INQUIRY INTO IMPACT OF THE ROZELLE INTERCHANGE

ROZELLE INTERCHANGE – ACTIVE TRANSPORT NON-COMPLIANCE AND DEFECTS REPORT

Prepared for
Department of Planning, Housing and Infrastructure, Transport for NSW, Sydney
Transport Partners, and Inner West Council

Rozelle Interchange – Active Transport Non-compliance and Defects Report (attached)

Victoria Road - southwestern side

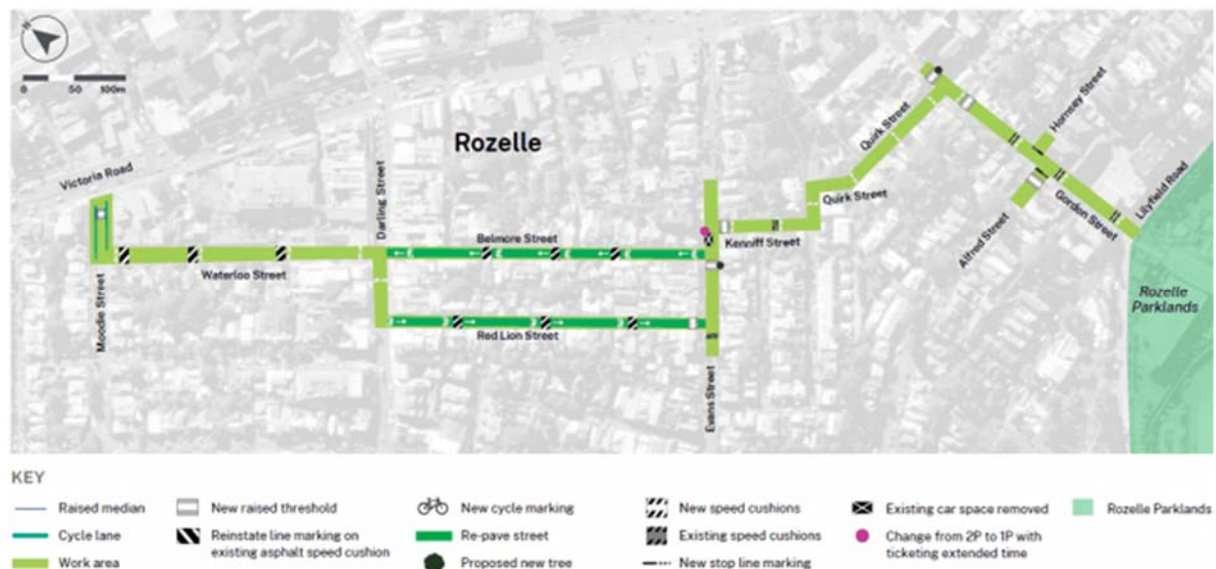
The 330 metres of shared path between the southern end of the Iron Cove Bridge and Springside Street is the only new cycling infrastructure on Victoria Road. It is reasonable although the kerb ramps could be wider and better aligned with the direction of cycling. We recommend that signs warning drivers turning off Victoria Road to look out for cyclists when crossing the cycle path.

East of Springfield Street, the existing cycle route suffers from the same problems as the shared path on the northern side of Victoria Road; poles, bus stops, other encumbrances and bad surfaces.

The section opposite Robert Street is particularly dangerous; it is narrow, poorly surfaced and adjacent to fast-moving traffic. This is a major defect.

Junction with Anzac Bridge shared path

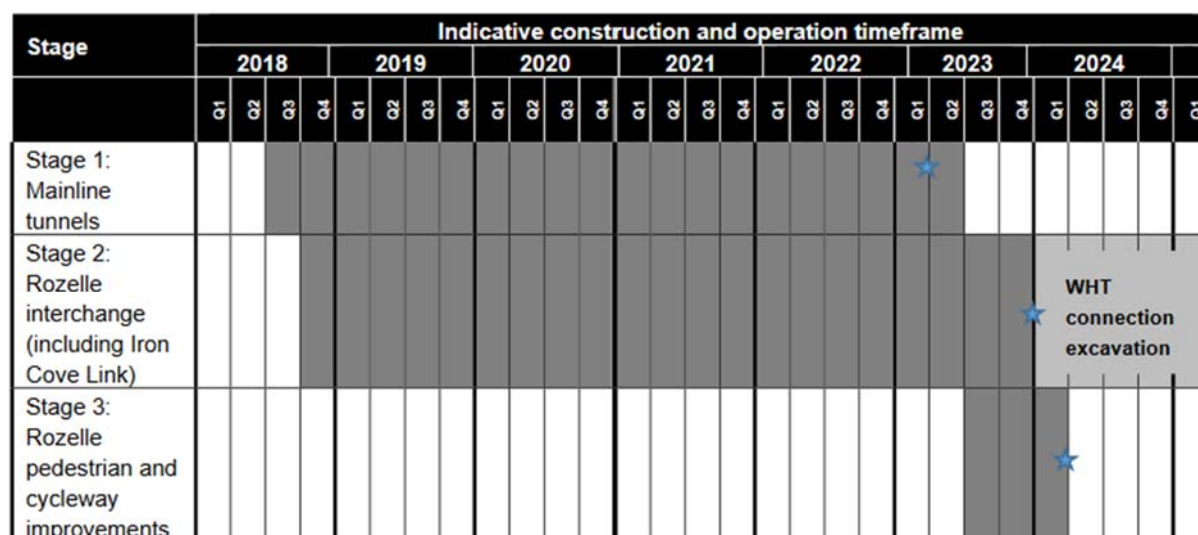
The junction between the path under the Victoria Road Bridge and the path from Victoria Road to the Anzac Bridge is potentially dangerous. It involves a 180° U-turn for cyclists arriving from Victoria Road and going through the Rozelle parklands and vice versa. This manoeuvre must be done in a tight space and is challenging for less experienced cyclists. There is potential for an accident with fast-moving cyclists travelling downhill from the Victoria Road Bridge towards the Anzac Bridge.

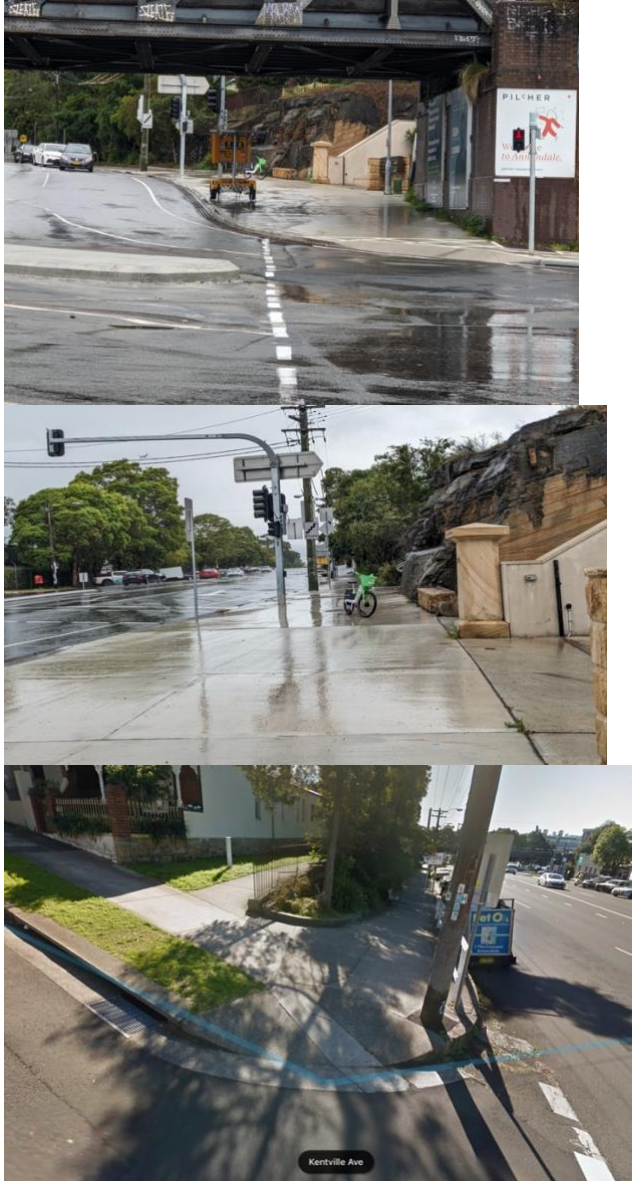
Item	Problem	Recommendation	Illustration
11	Path entrance to Rozelle Bay Light Rail station from Railway Pde is awkward and has poor sight lines	Reconfigure entrance to provide better safety for pedestrians and cycle users.	 <p>The photograph shows a street scene from a pedestrian's perspective. In the foreground, there is a concrete sidewalk that appears to be the entrance to a path. A large tree stands on the left side of the sidewalk. To the right of the tree, there is a white van parked on the street. Further down the road, there are several other vehicles parked, including a dark car and a white van. The road is paved and curves to the right. The background is filled with green trees and foliage. The overall scene suggests a residential or suburban area with a mix of pedestrian and vehicle traffic.</p>

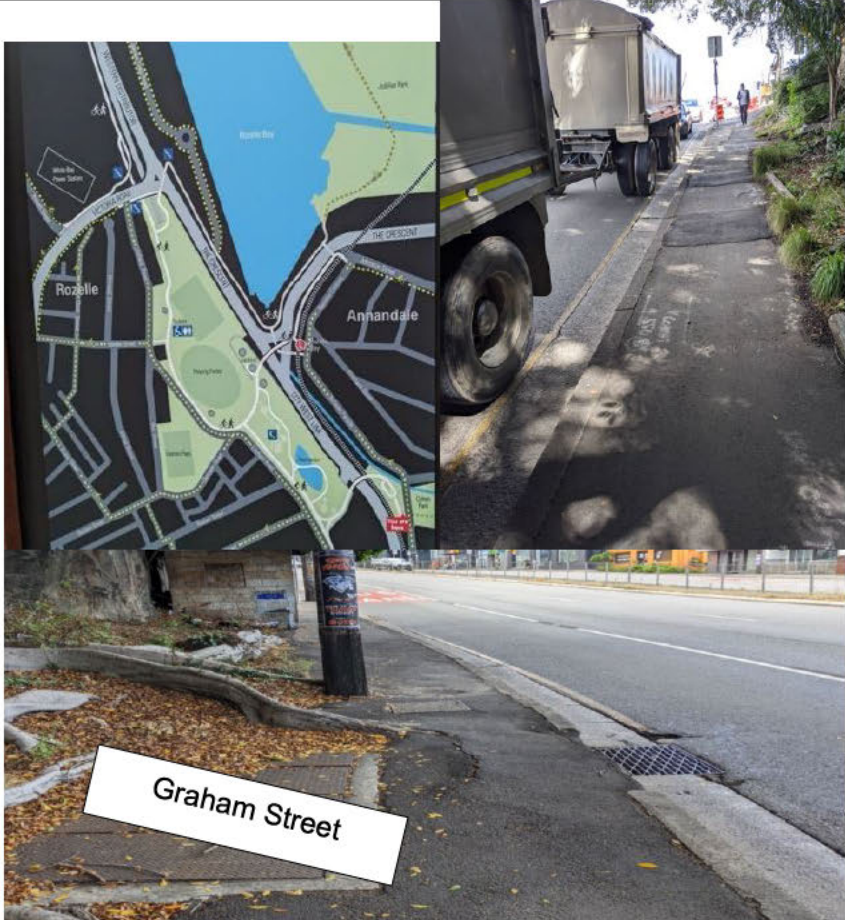
Item	Problem	Recommendation	Illustration
15	Current 50km/h speed limits on streets adjacent to the Rozelle Parklands are too high, given the changed usage and character of the area	Lower speed ratings on Gordon St (from Victoria Rd to across Lilyfield Rd into Parklands), Brenan St and Railway Pde, and Lilyfield Rd from Victoria Rd to Ryan St. These are all Low Traffic Neighbourhoods and should be progressively lowered to 30km/h.

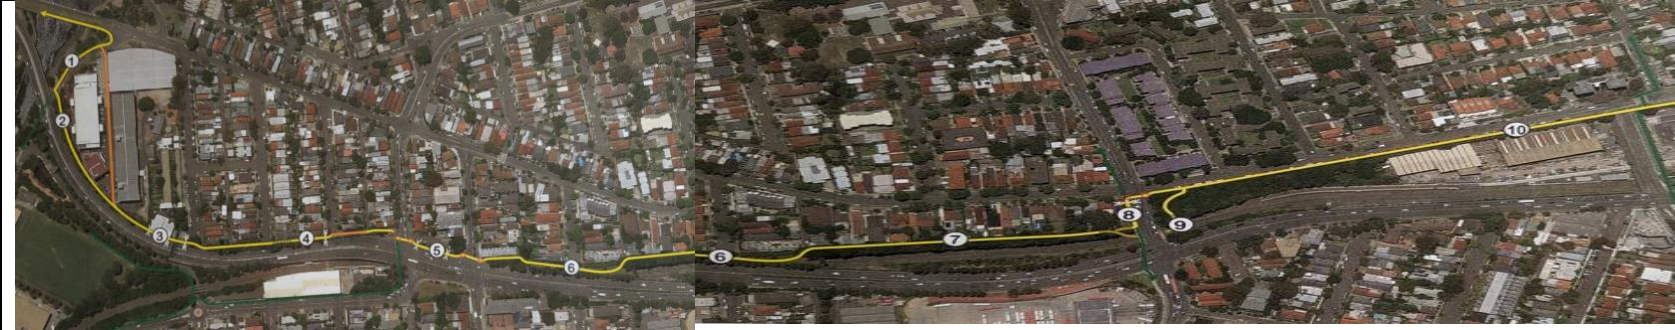
Item	Problem	Recommendation	Illustration
20	Cycle lanes on Balmain Rd between City West Link and Lilyfield Rd are discontinuous, making this a barrier to safe cycle movement across this major intersection	Reconfigure lanes and unused footpath space on east side of rail bridge and CWL crossing to facilitate continuous north/south safe cycle movement on <u>both</u> sides of Balmain Rd.	 <p>Balmain Rd, East side</p>

Item	Problem	Recommendation	Illustration
20 (cont)			<div data-bbox="1066 228 1522 553">  </div> <div data-bbox="1598 370 1780 435"> <p>Balmain Rd, West side</p> </div> <div data-bbox="1066 553 1900 1002">  </div>
